Technical Service Bulletin

GROUP CAMPAIGN	NUMBER 18-01-010-1
DATE APRIL, 2018	MODEL(S) TUCSON (TL)

SUBJECT: EVAPORATOR TEMPERATURE SENSOR REPLACEMENT AND ECU UPDATE (SERVICE CAMPAIGN T2U)

This TSB supersedes TSB 18-01-010 to provide an updated ROM ID Information Table.

Part Name	Part Number	Figure
Evaporator Temperature Sensor	97143-C5000QQH

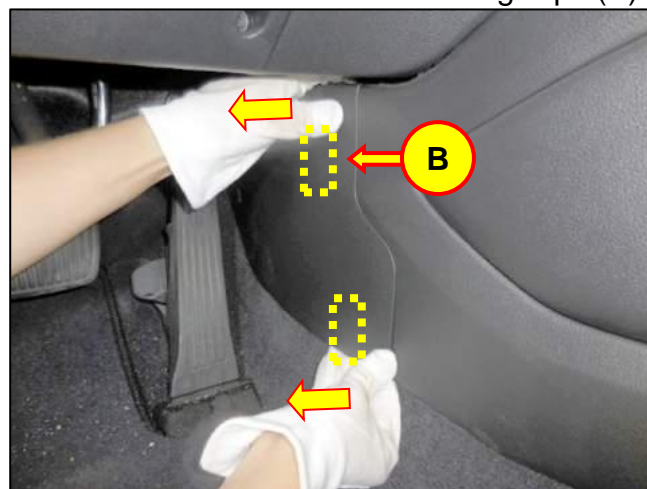
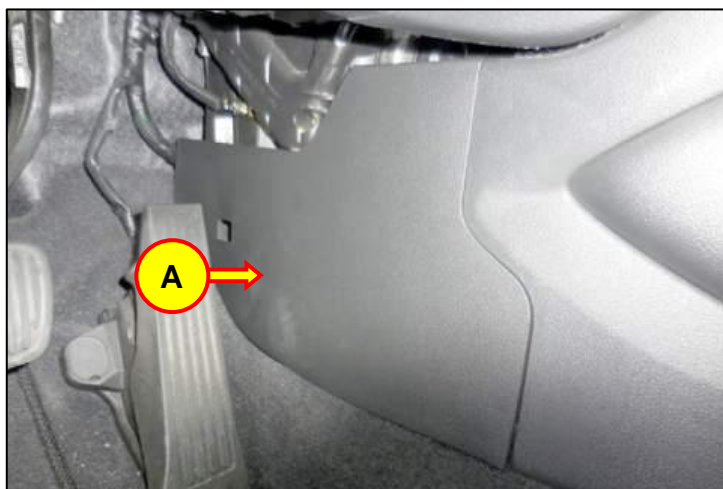
This bulletin provides information to replace the A/C Evaporator Temperature Sensor and to update the HVAC ECU on certain 2016-2017 model year Tucson (TL) vehicles.
